Re: Enbridge Gas Inc. (Enbridge Gas)
Ontario Energy Board (OEB) File No. EB-2022-0335
Integrated Resource Planning (IRP) Pilot Projects
Updated Evidence

Pursuant to Procedural Order #3 dated November 17, 2023, and the letter filed by Enbridge Gas on November 30, 2023, please find attached Enbridge Gas's evidence update for the above noted proceeding.

Answer to Interrogatory from
Ontario Energy Board Staff (STAFF)

FIGURE 1

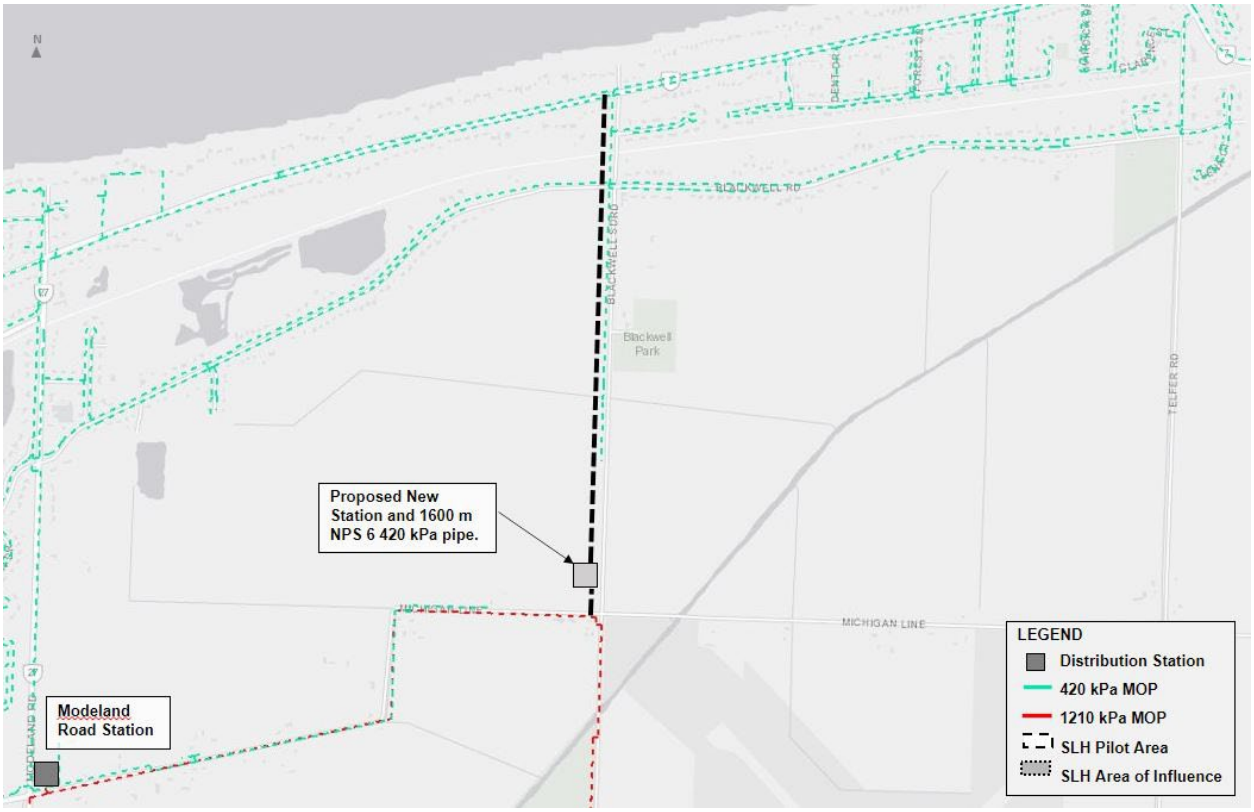
Please see response at Exhibit I.FRPO-15 for the current system constraint location. See Figure 1 for a simpler map of the proposed station. Detailed design has not taken place and therefore station location and inlet pipe size are still to be determined.

a) The Southern Lake Huron Pilot Project area was verified using January 11, 2022, data to within 5% of the system Maximum Operating Pressure ("MOP"). Please see the verification report at Attachment 1. The pressure recording devices used for verification are often attached to customer services as these devices need to be above ground. The redactions in Attachment 1 have been done to protect customer names.

Figure 4 – Map of Southern Lake Huron Pilot Area

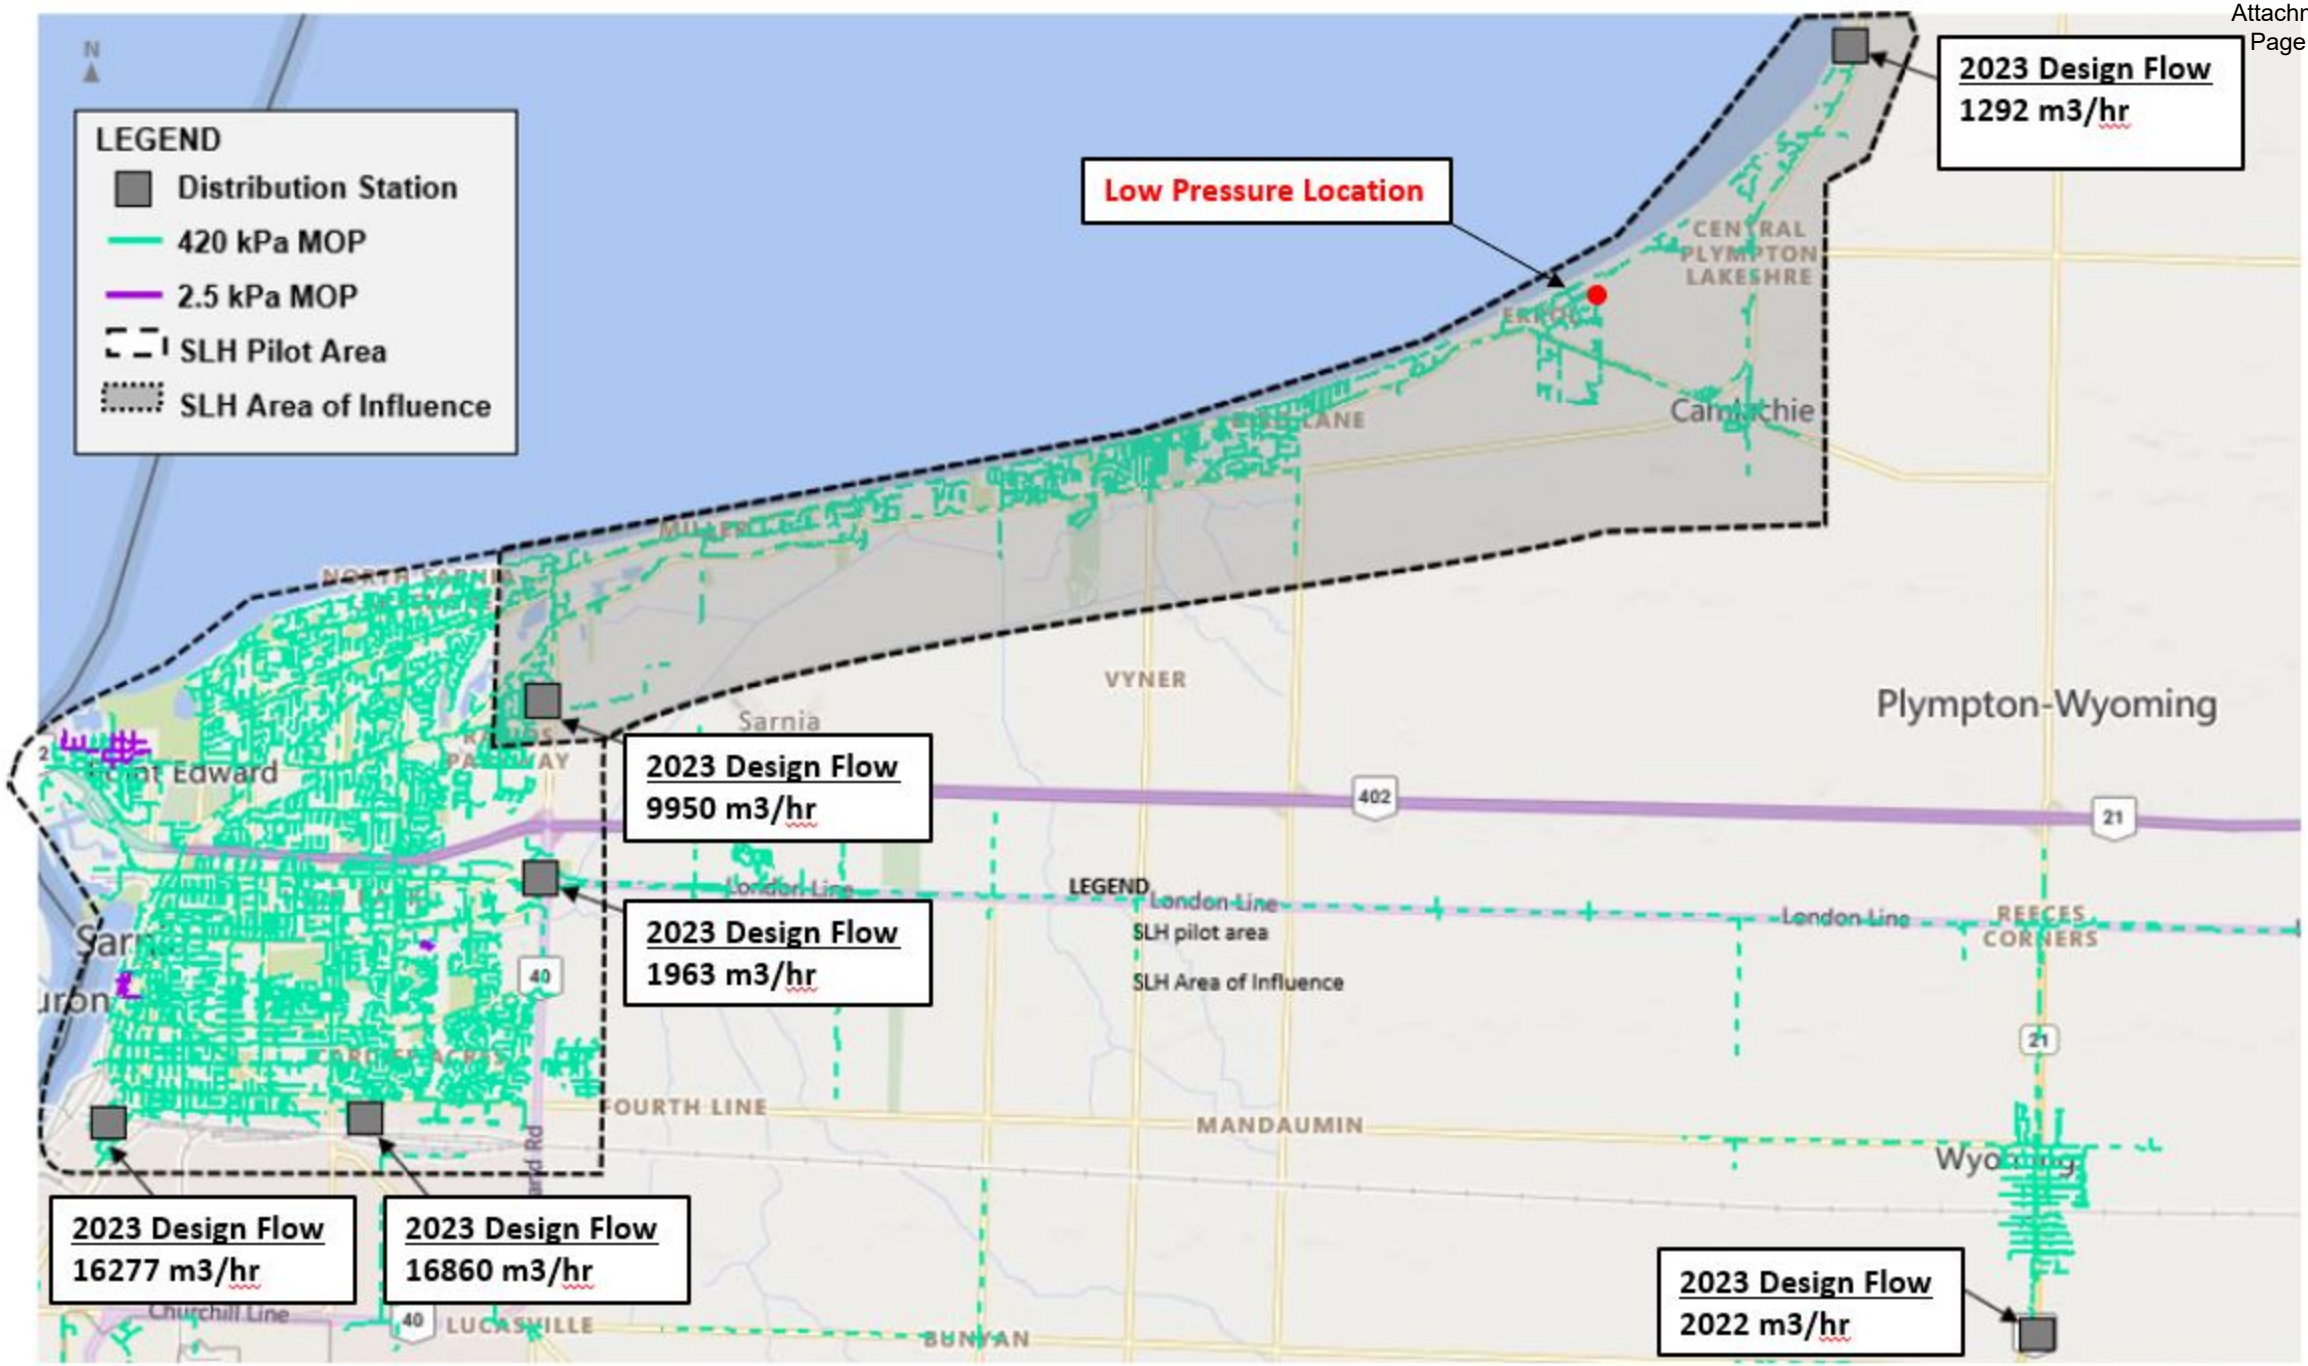
c) None of the distribution stations shown in Figure 4, Exhibit B, Tab 1, Schedule 1, page 11 of 15 have flow measurement.

d) To upgrade the six distribution stations that do not currently have flow measurement, the cost is estimated to be approximately $4.5 million.

Figure 2 – Southern Lake Huron Pilot Project Area

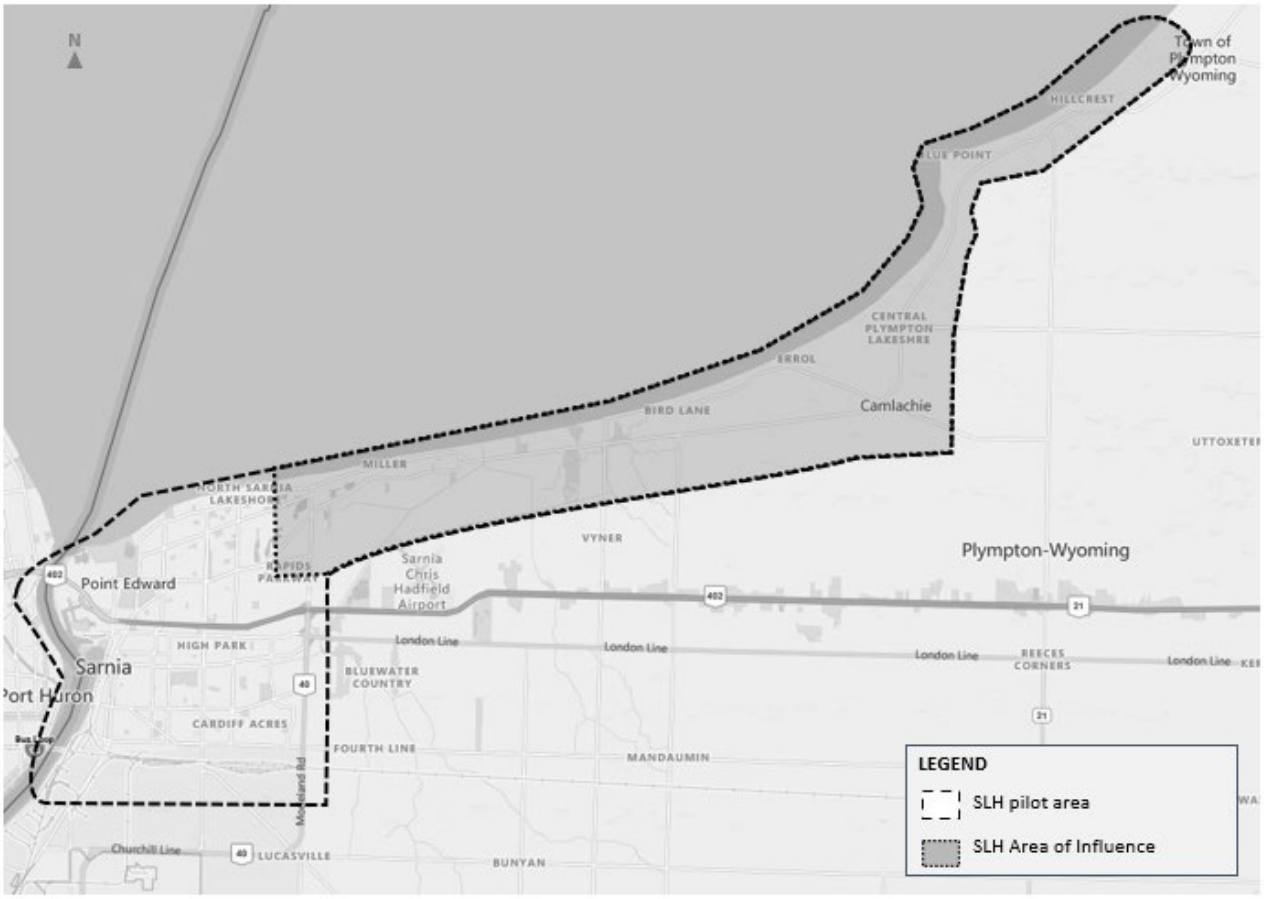
27	where on map?	Ref: Exhibit C, Tab 1, Schedule 2, Paragraph 10 Regarding system configuration, the Area of Influence was defined on a map in Exhibit A, Tab 2, Schedule 1, Attachment 1 Figure 2.
28	Does this preclude Federal funds?	Ref: Exhibit D, Tab 1, Schedule 1, Paragraph 6 Inclusion of NRCan does not impact the proposed attribution for the Pilot Projects, and program incentives from federal funds are not impacted.
29	enhanced incentives vs. benefit of deferral	Ref: Exhibit D, Tab 1, Schedule 1, Paragraph 47 The impact of Pilot Projects on the baseline facilities were explained at the end of the Exhibit and considered in Exhibit E, Stage 1 NPV calculation.

Figure 1 – Schematic of Parry Sound system

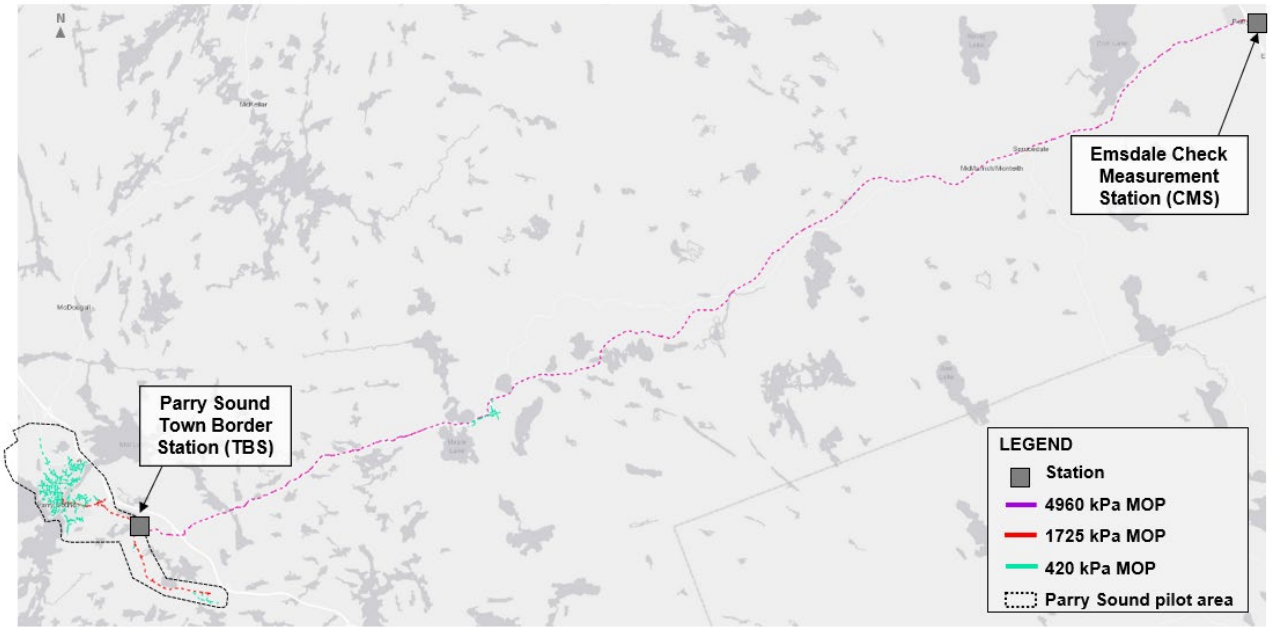
19	pipe size???	Ref: Exhibit B, Tab 1, Schedule 1, Figure 1 Information was provided in subsequent paragraph. No further updates.
20	price associated with what???	Ref: Exhibit B, Tab 1, Schedule 1, Paragraph 13. Information was provided in Exhibit D, Tab 1, Schedule 1. No further updates.
21	segmentation of existing 2,100?	Ref: Exhibit B, Tab 1, Schedule 1, Table 1. Information was provided in Exhibit D, Tab 1, Schedule 1. No further updates.
22	sources of gas to stations - feeding pipelines?	Ref: Exhibit B, Tab 1, Schedule 1, Figure 4. Upstream pipelines and system are not in scope of this Pilot Project. No future updates.
